GW - 47

**GENERAL
CORRESPONDENCE**

RE: Discharge Plan GW-47
Lybrook Gas Plant
Rio Arriba County, New Mexico

SUNTERRA'S RESPONSE TO OCD DEFICIENCIES-LYBROOK WASTE DISCHARGE PLAN

PROPOSED WATER SEPARATOR FOR SUNTERRA GAS
PROCESSING COMPANY TO BE INSTALLED AT LYBROOK PLANT
K.E. LAWRENCE , JULY 17 ,1989 , NO SCALE , FILE NAME: EXH-4-A

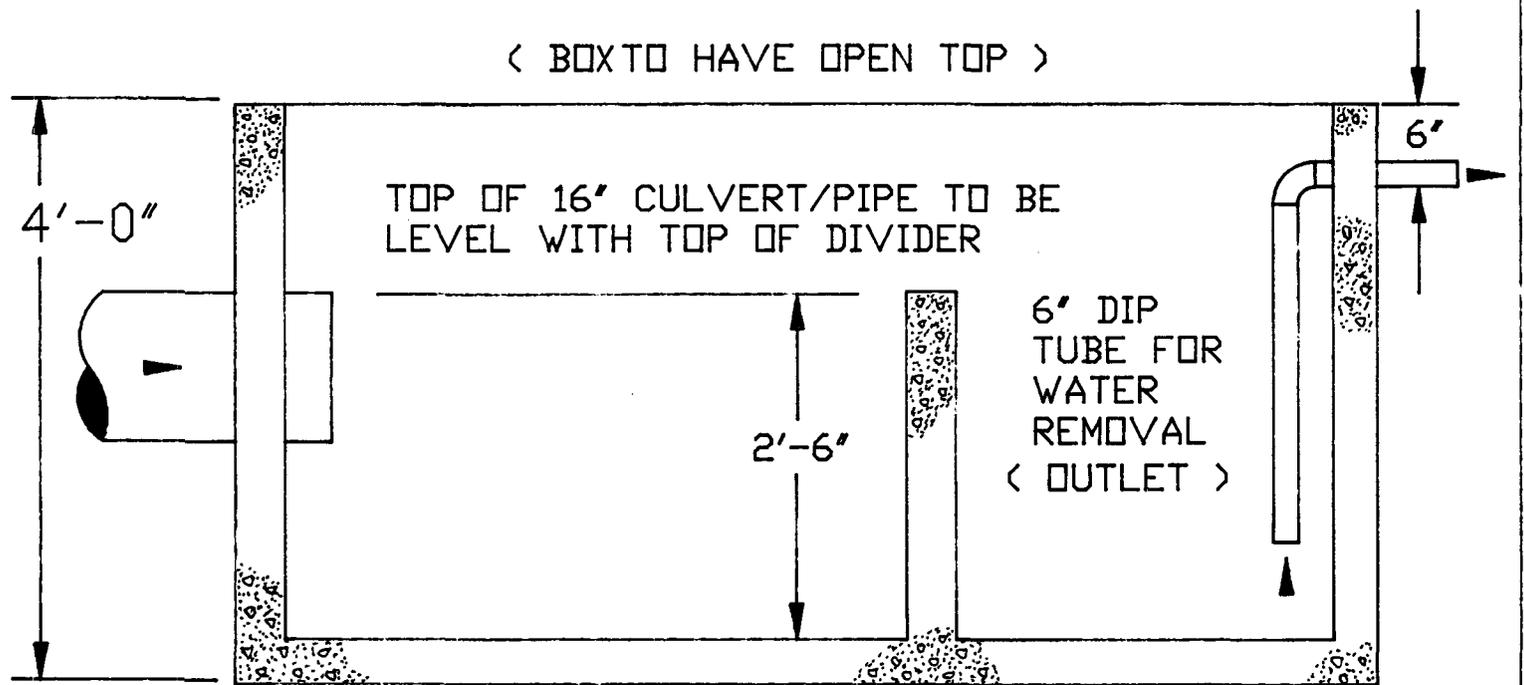
3. Sunterra has committed to install oil/water separators for the plant drain system and in the drainage channel that drains the runoff from the process area. What is the specific location of the drainage channel separator. Submit the proposed designs and completion time tables.

NOTE:
WALLS, FLOOR & DIVIDER ALL TO BE
4" THICK CONCRETE CONSTRUCTION

EXHIBIT 10. Fence diagram illustrating subsurface relations encountered, pond area, Lybrook Plant site.

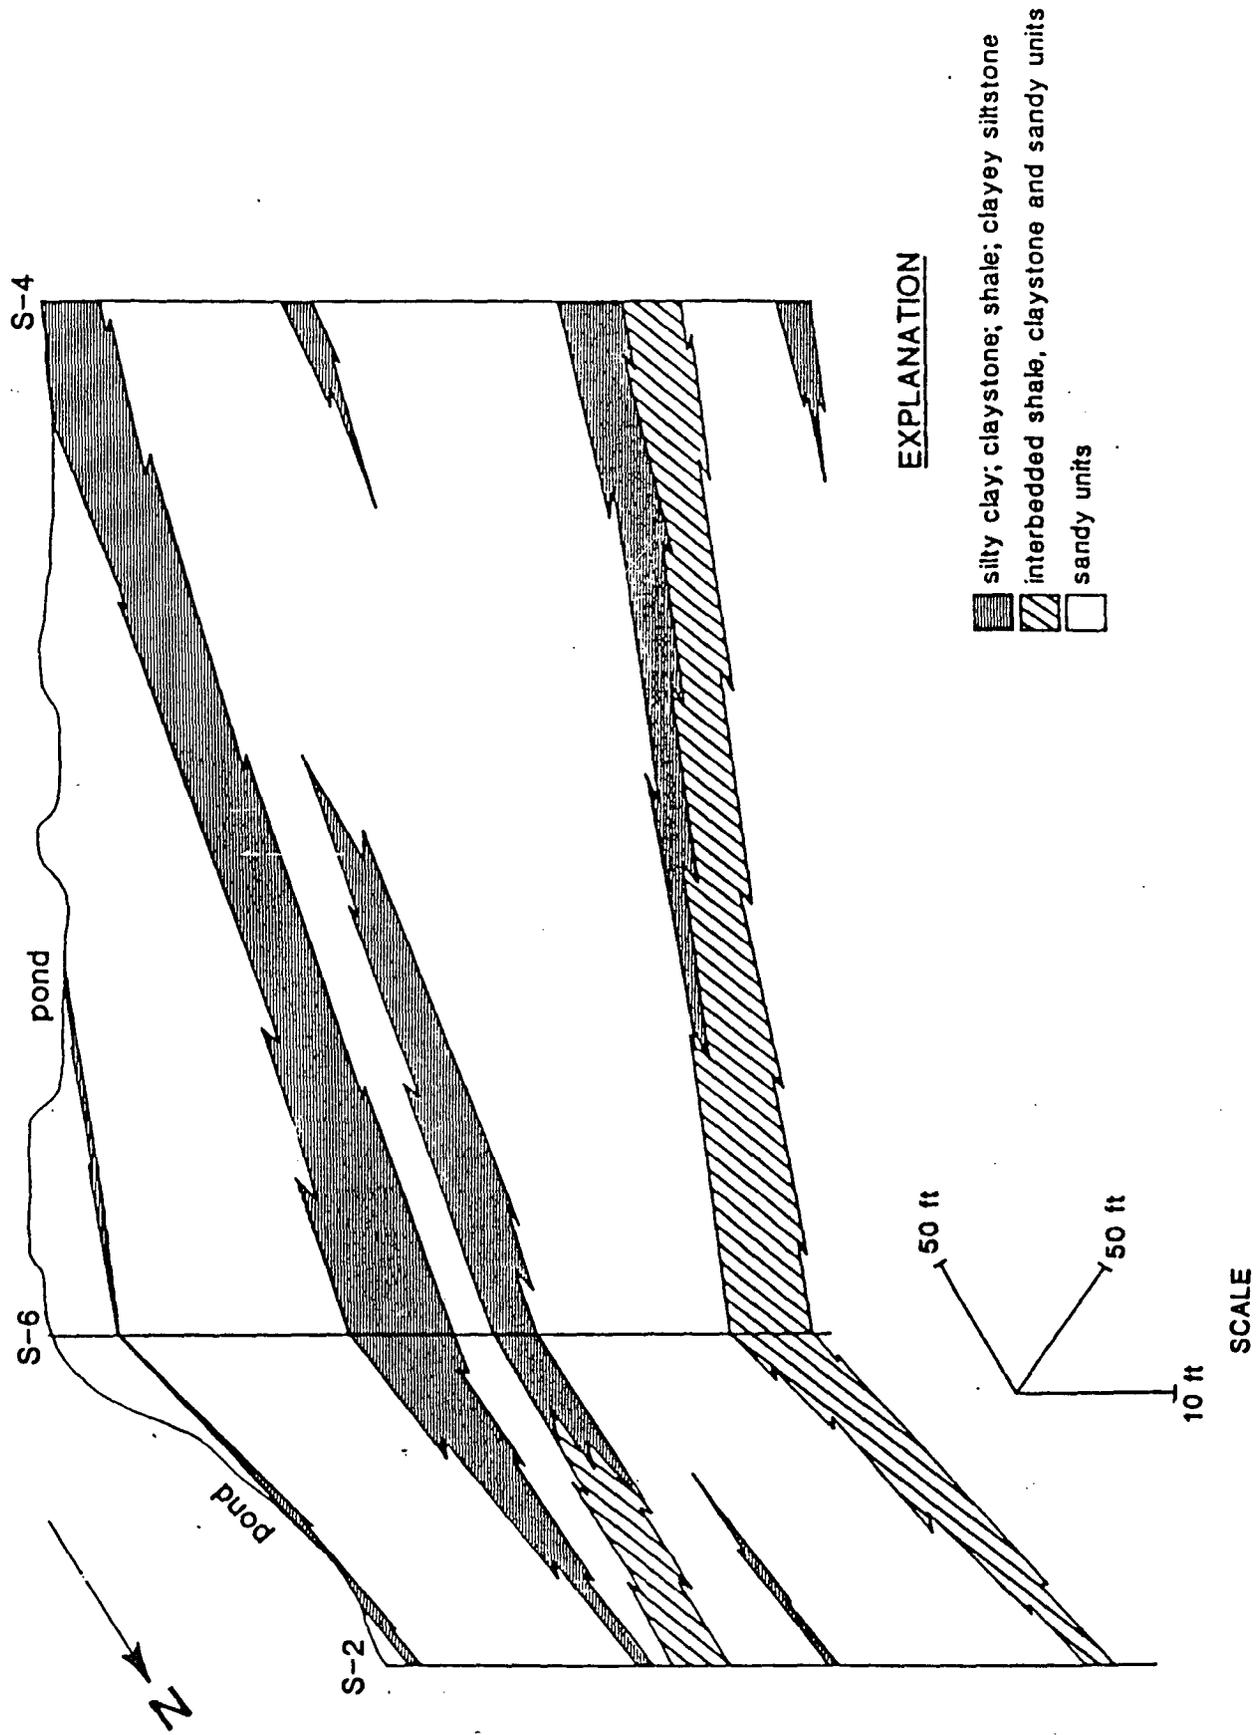
4. Which specific zones on the individual well logs are used to show the "clay-rich sediments" drawn on the Exhibit 10 fence diagram?

7. Before making a decision on continued use of the ponds, the OCD will require that a monitoring well be located between S-1 and S-4 at a location shown on Exhibit 10 (attached). The well should be approximately 50 feet from both ponds 1 and 2. If fluids are detected perched on top of the anticipated clay zone (at about 7088-90 feet), the well should be dual completed. Before proceeding with drilling this well, Sunterra's consultant should meet with us to discuss specifics of this request and provide information requested in items 4-6 above.

Figure-3. Topographic map of pond area, Lybrook Plant site; showing drill-hole locations and section lines (see Figure 4).

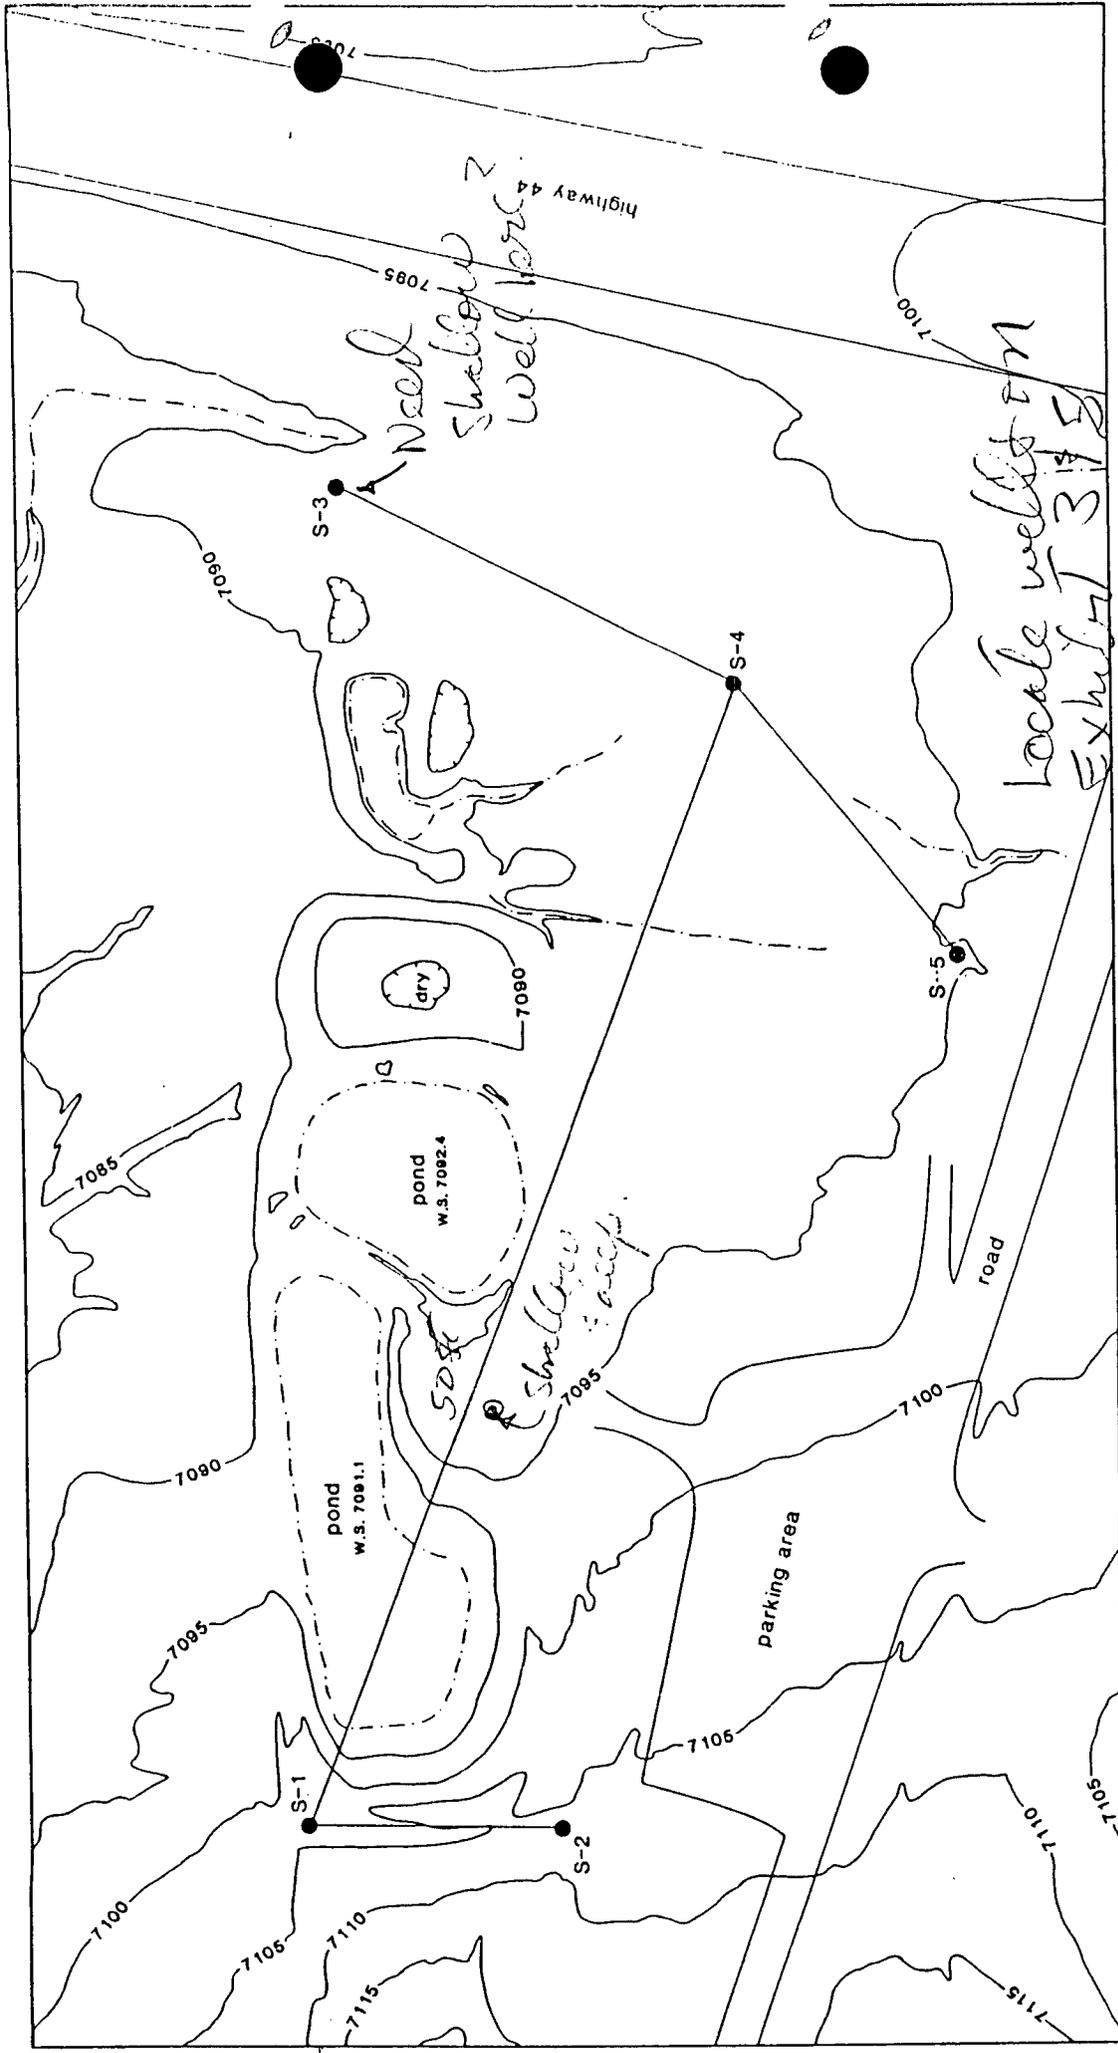
Need Shallow Well here?
 Need to measure H₂O
 Locate well in Exhibit 315

Figure-3. Topographic map of pond area, Lybrook Plant site; showing drill-hole locations and section lines (see Figure 4).

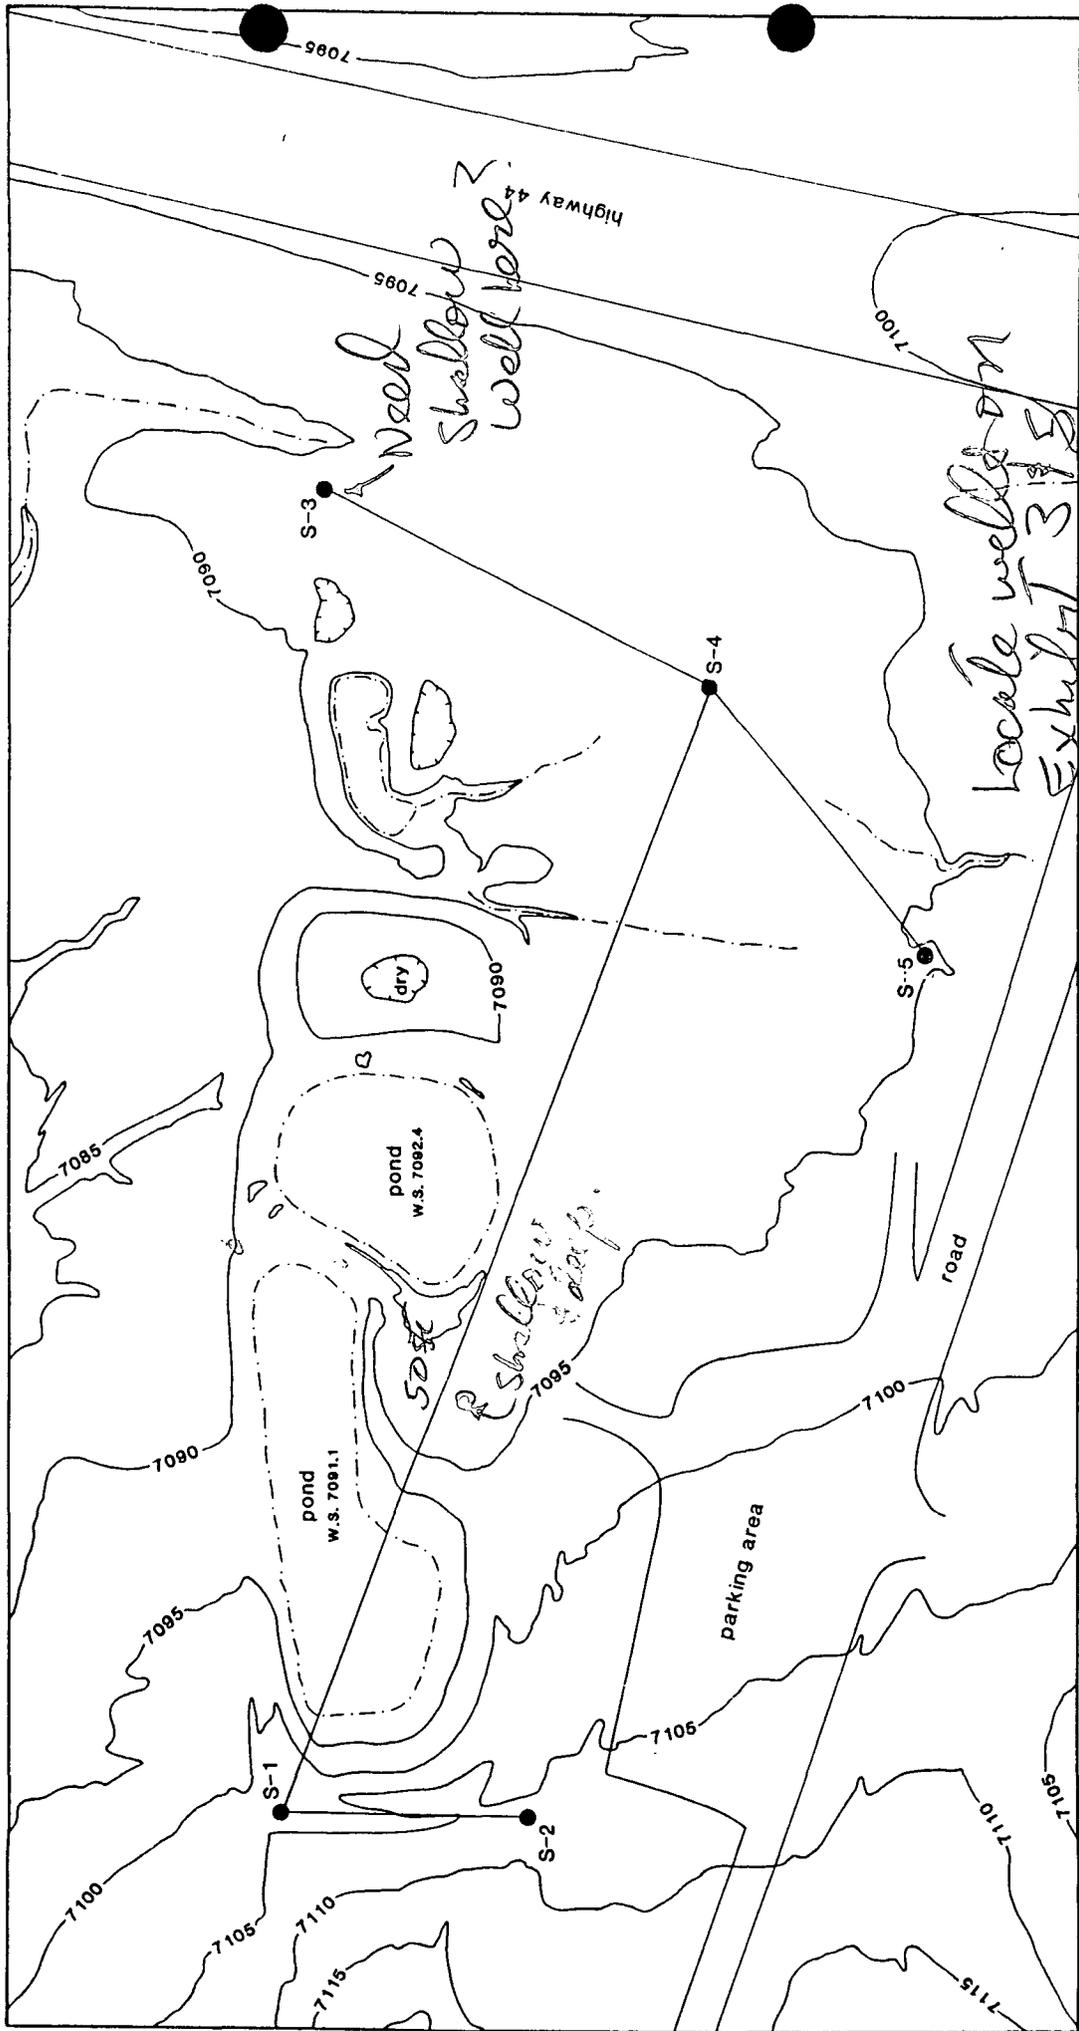
Need Shallow Well here?
 locate well on Exhibit 3 of S
 SCALE 0 50 feet
 Need to have Elevation to correlate & carry it to measure by D
